PROJECT REFERENCE NO.	SHEET NO.
U-3465	Sig. 6.1

Electrical Detail - Temp 1 (Phase I - Step 2)

ELECTRICAL AND PROGRAMMING DETAILS FOR:

NC 210
at
SR 1121 (Ray Road)/
SR 2051 (Sandclay Road)

EDI MODEL 2010ECL CONFLICT MONITOR PROGRAMMING DETAIL

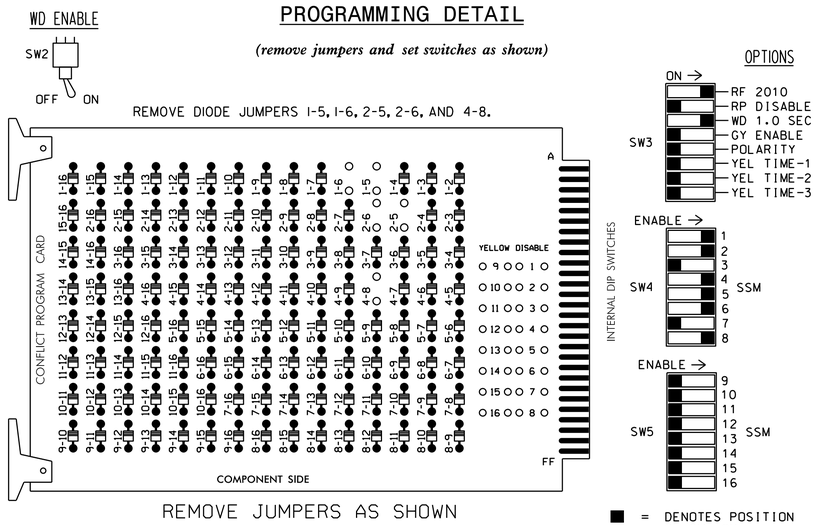
▽1 2. Make sure jumpers SEL2-SEL5 are present on the monitor board.

REVISIONS	INIT.	DATE
▽1 Removed 5-section head 42, revised monitor settings, removed loop 5C, revised delays, added a note. (WSA)	JTR	6/25/2014

INPUT FILE POSITION LAYOUT

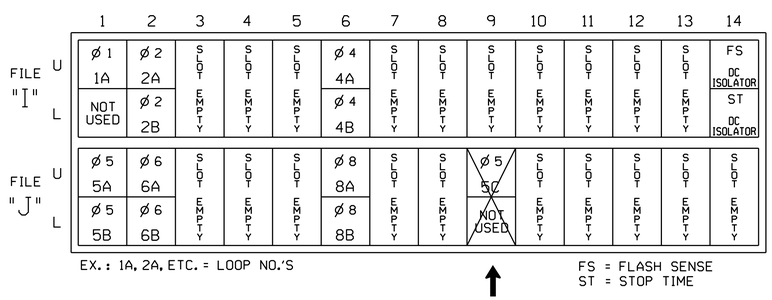
▽1 REMOVE DETECTOR CARD

LOOP NO.	LOOP TERMINAL	INPUT FILE POS.	PIN NO.	INPUT ASSIGNMENT NO.	DETECTOR NO.	NEMA PHASE	CALL	EXTEND	FULL TIME DELAY	STRETCH TIME	DELAY TIME
1A	TB2-1,2	I1U	56	18	1	1	Y	Y			
2A	TB2-5,6	I2U	39	1	2	2	Y	Y			
2B	TB2-7,8	I2L	43	5	12	2	Y	Y			
4A	TB4-9,10	I6U	41	3	4	4	Y	Y			3
4B	TB4-11,12	I6L	45	7	14	4	Y	Y			10
5A	TB3-1,2	J1U	55	17	5	5	Y	Y			
5B	TB3-3,4	J1L	55	17	5	5	Y	Y			
6A	TB3-5,6	J2U	40	2	6	6	Y	Y			
6B	TB3-7,8	J2L	44	6	16	6	Y	Y			
8A	TB5-9,10	J6U	42	4	8	8	Y	Y			3
8B	TB5-11,12	J6L	46	8	18	8	Y	Y			10
~~5C~~	~~TB7-9,10~~	~~J9U~~	~~59~~	~~21~~	~~15~~	~~5~~	~~Y~~	~~Y~~			~~15~~
